CITY OF PUNTA GORDA ADA TRANSITION PLAN FINAL REPORT Harborwalk East

October 4, 2017

Prepared For:
City of Punta Gorda
326 West Marion Avenue
Punta Gorda, Florida, 33950

Figure 4-2 – Low hanging tree branches

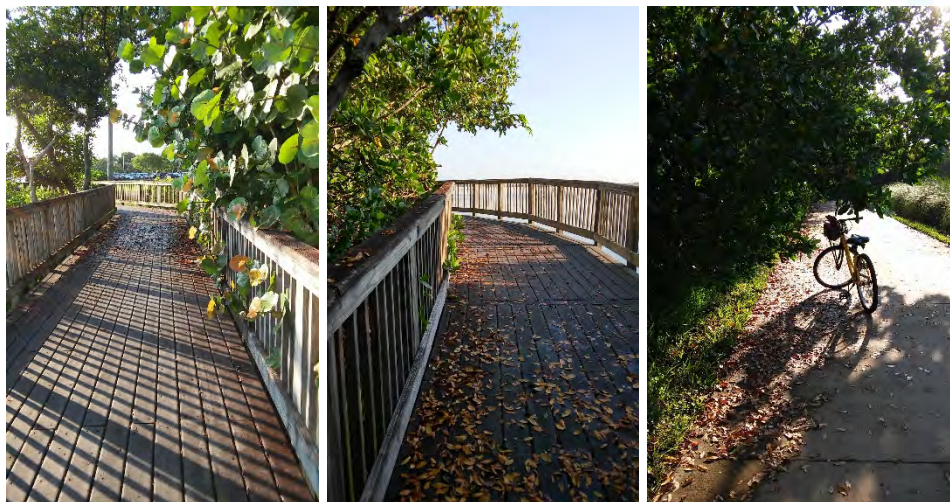
Vertical clearance is defined as the minimum unobstructed vertical passage space. Vertical clearance is often limited by obstacles such as building overhangs, tree branches, signs, and awnings. Shown below in Figure 4-2, various sections of the Harborwalk East trail contains low hanging tree branches, which protrude and obstruct the pathway. A map of these locations is provided in Appendix A.

ADAAG states that, “objects with leading edges more than 27 inches and not more than 80 inches above the finish floor or ground shall protrude 4 inches maximum horizontally into the circulation path.

Trim and maintain the tree branches so they do not protrude more than 4” onto the path for a height of at least 80 inches. This will prevent visitors with visual impairments from not being able to detect and then make contact with the hazardous object.

Figure 4-3 – Select locations with non-compliant cross slopes.

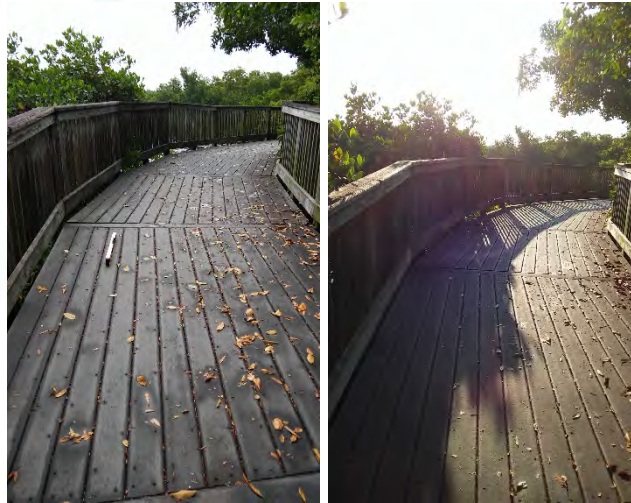
Per **ADAAG 403.3**, the running (perpendicular) slope of a walking surface shall not be steeper than 5%. If a slope exceeds 5%, it is considered a ramp, per **ADAAG 405.2**, and the running slope must not exceed 8.33%. In addition, ramps must have landings, handrails, and edge protection, per **ADAAG 405**.

As such, 8 segments of the Harborwalk East multiuse trail were found to have slopes in excess of this requirement, as shown in the photos below and detailed in Appendix A.

The locations that have non-compliant running slopes must be either resurfaced/reconstructed or include the addition of handrails and landings, as long as their slope is not steeper than 8.33%, as specified in **ADAAG 405**.
